Access Compliance Report

Public Rights-of-Way

(Curb Ramps)

Intersection ID: 16072	Main Street: MONROE_RD	Cross Street: RICHLAND_DR	Location: NE
ADA ID: C400FE5CFC55	Ramp Type: Perp	Initial Pass/Fail: Fail	Overall Compliance: No
Severity Score: 8.75			
Codes/Mitigation Info/Possible Solution		Field Measurements/Component Compliance

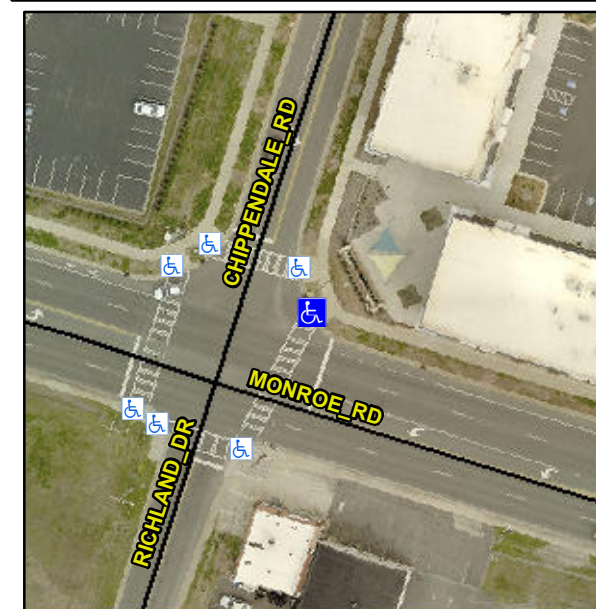
Not Found, R304.5.1

Compliance	Description	Data	Compliance	Description	Data
N/A	Ramp Length (in)	96.0	Yes	Ramp Slope (%)	6.5
No	Ramp Width (in)	44.0	Yes	Ramp XSlope (%)	0.5
N/A	Flare Type LT	N/A	N/A	Flare Type RT	N/A
N/A	Flare Slope LT (%)	N/A	N/A	Flare Slope RT (%)	N/A
N/A	Flare Traversable LT?	N/A	N/A	Flare Traversable RT?	N/A
N/A	Landing Length (in)	N/A	N/A	DWS Provided?	N/A
N/A	Landing Width (in)	N/A	N/A	DWS Contrast?	N/A
N/A	Landing Slope (%)	N/A	N/A	DWS Length (in)	N/A
N/A	Landing X Slope (%)	N/A	N/A	DWS Full Width?	N/A
N/A	Landing Curb? (Y/N)	N/A	N/A	DWS Offset (in)	N/A
N/A	Shared Landing?	N/A			
N/A	Gutter Ponding?	N/A	N/A	Gutter Slope (%)	N/A
N/A	Gutter Lip Ht (in)	N/A	N/A	Gutter X Slope (%)	N/A
N/A	Painted X Walk1?	Yes	N/A	Painted X Walk2?	N/A
	X Walk 1 Direction	To SW		X Walk 2 Direction	N/A
N/A	X Walk 1 Width (in)	114.0	N/A	X Walk 2 Width (in)	N/A
	X Walk 1 Slope (%)	2.1		X Walk 2 Slope (%)	N/A
	X Walk 1 X Slope (%)	1.1		X Walk 2 X Slope (%)	N/A

Remove & Replace Entire Ramp.
